Access Compliance Report

Public Rights-of-Way (Curb Ramps)

| Intersection ID: 44216 | Main Street: ROZZELLES_FERRY_RD | Cross Street: ROZZELLES_LANDING_DR | Location: S |
| ADA ID: 42CBA6C81CF9 | Ramp Type: Perp | Initial Pass/Fail: Fail | Overall Compliance: No |

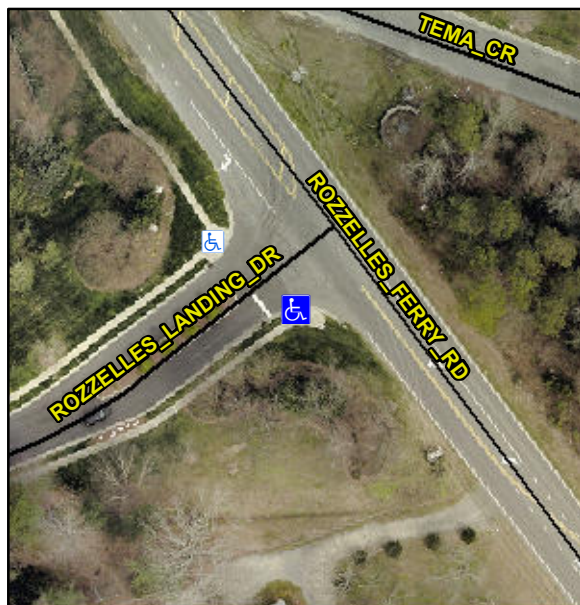
R304.5.1, R304.2.2

| Compliance | Description | Data | Compliance | Description | Data |
|------------|-----------------------|-------|------------|-----------------------------|------|
| N/A | Ramp Length (in) | 49.0 | No | Ramp Slope (%) | 9.9 |
| No | Ramp Width (in) | 37.0 | Yes | Ramp XSlope (%) | 1.4 |

Remove & Replace Entire Ramp.
